PA-479 DAM

NDI I.D. NO: PA-509

PHASE I INSPECTION REPORT  
NATIONAL DAM INSPECTION PROGRAM

National Dam Inspection Program, PA-479  
Dam (NDI ID Number PA-509, DER ID  
Number 63-71), Ohio River Basin, Harmon  
Creek, Washington County, Pennsylvania.  
Phase I Inspection Report.

PLATE 12  
 PA.479 DAM  
 GENERAL PLAN  
 FIELD INSPECTION NOTES  
 FIELD INSPECTION DATE: DEC. 5, 1978

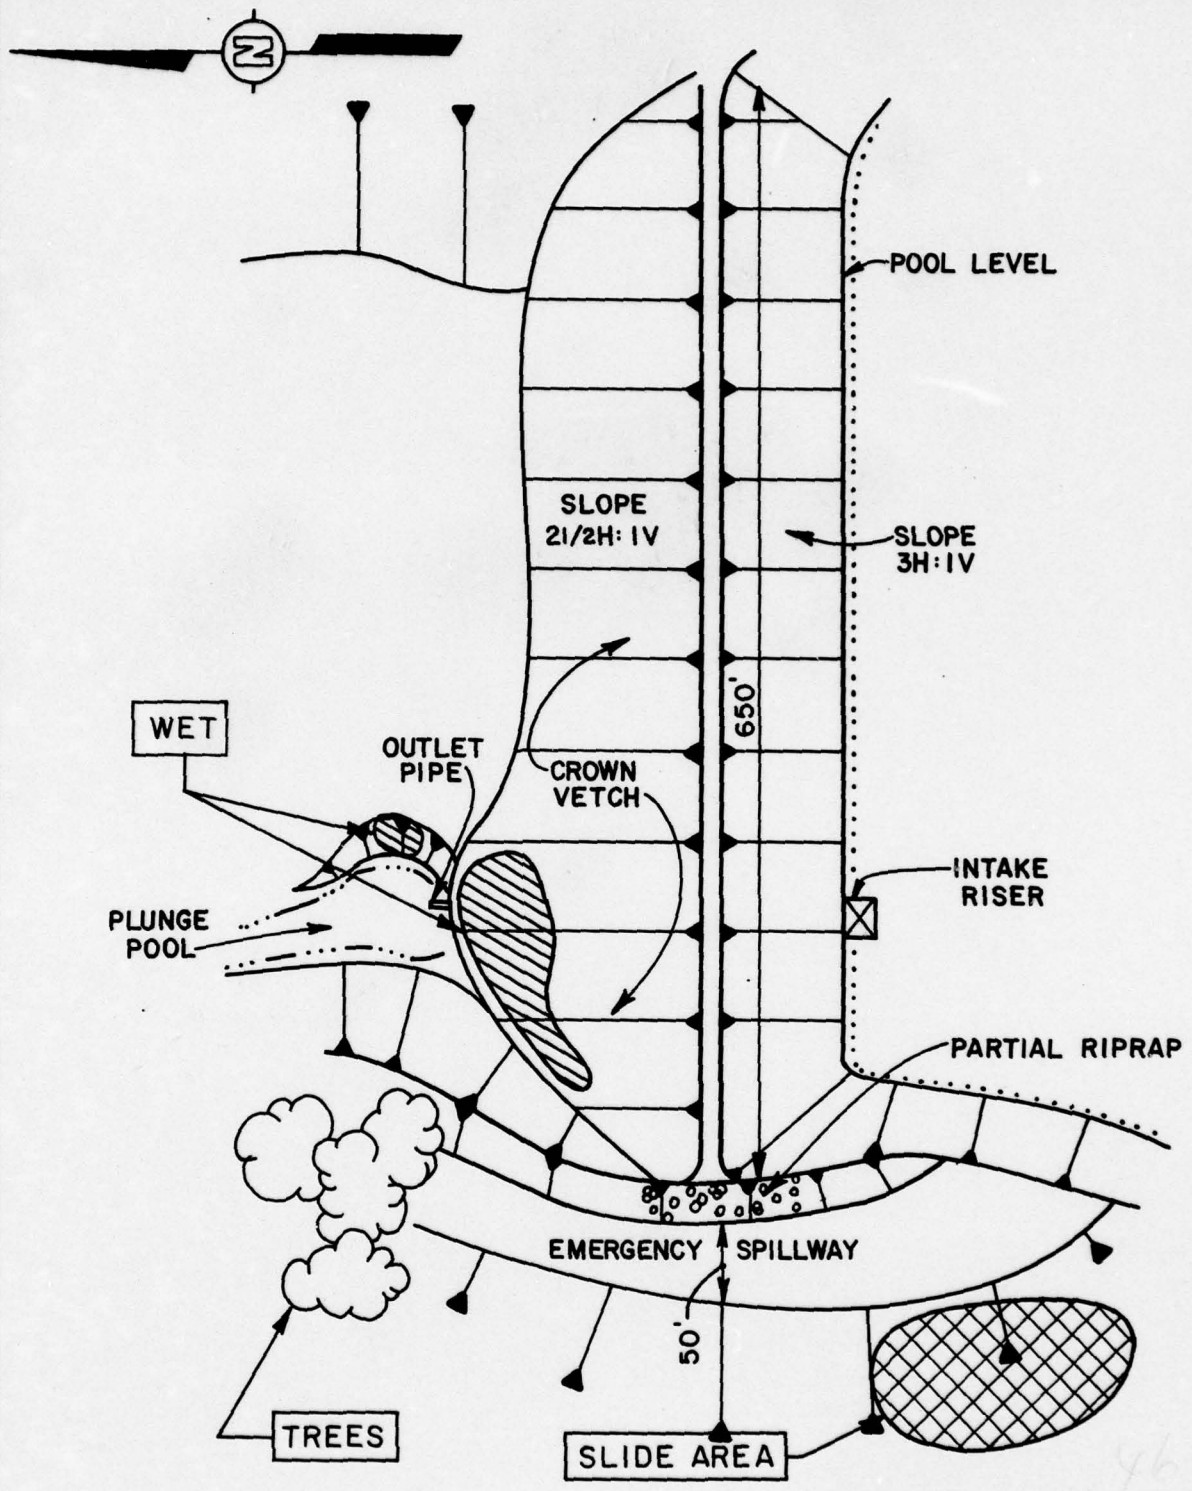
The specific observations are illustrated in Plate 12 and in the photographs in Appendix C.

In general, the condition of the dam is considered to be good. Only one wet area was observed on the downstream slope near the left abutment immediately above the outlet works plunge pool. No perceivable seepage was associated with this wet area. The slope adjacent to the emergency spillway was found to be wet and irregular, suggesting a progressing slide.

1. The slope adjacent to the emergency spillway should be stabilized to prevent development of a slide which would block the spillway.
2. The wet area located on the downstream slope should be periodically observed to document if a seepage condition is developing. Necessary remedial work should be performed if such conditions develop.
3. An around-the-clock surveillance should be provided during unusually heavy runoff and
